Access Compliance Report

Public Rights-of-Way

(Curb Ramps)

Intersection ID: 18259	Main Street: OLD_PINEVILLE_RD	Cross Street: ROUNTREE_RD	Location: SW
ADA ID: 23AFB0F147AE	Ramp Type: ParaDiag	Initial Pass/Fail: Pass	Overall Compliance: No
		Severity Score: 0.25

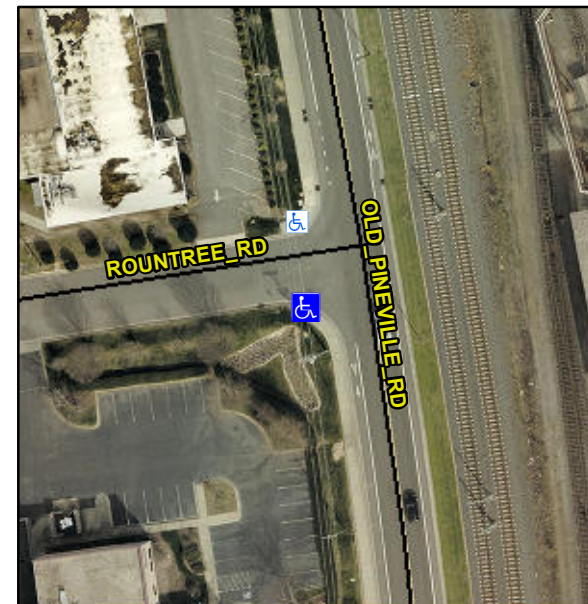
R304.5.3, R305.2

Compliance	Description	Data	Compliance	Description	Data
N/A	Ramp Length LT (in)	66.0	N/A	Ramp Length RT (in)	51.5
Yes	Ramp Width LT (in)	72.0	Yes	Ramp Width RT (in)	72.0
Yes	Ramp Slope LT (%)	6.2	Yes	Ramp Slope RT (%)	5.9
Yes	Ramp XSlope LT (%)	0.8	No	Ramp XSlope RT (%)	2.9
Yes	Landing Length (in)	72.0	Yes	DWS Provided?	Yes
Yes	Landing Width (in)	48.0	Yes	DWS Contrast?	Yes
Yes	Landing Slope (%)	2.0	Yes	DWS Length (in)	24.0
Yes	Landing X Slope (%)	0.6	Yes	DWS Full Width?	Yes
N/A	Landing Curb? (Y/N)	No	No	DWS Offset (in)	4.0
N/A	Shared Landing?	No			
Yes	Gutter Ponding?	No	Yes	Gutter Slope (%)	4.3
Yes	Gutter Lip Ht (in)	0.0	Yes	Gutter X Slope (%)	1.3
N/A	Painted X Walk1?	No	N/A	Painted X Walk2?	No
	X Walk 1 Direction	To E		X Walk 2 Direction	To N
N/A	X Walk 1 Width (in)	N/A	N/A	X Walk 2 Width (in)	N/A
	X Walk 1 Slope (%)	1.8		X Walk 2 Slope (%)	0.0
	X Walk 1 X Slope (%)	1.1		X Walk 2 X Slope (%)	0.1
N/A	Ramp inside XWalk1?	N/A	N/A	Ramp inside XWalk2?	N/A

Remove & Replace Curb Ramp With Two New Directional Ramps or Equivalent.
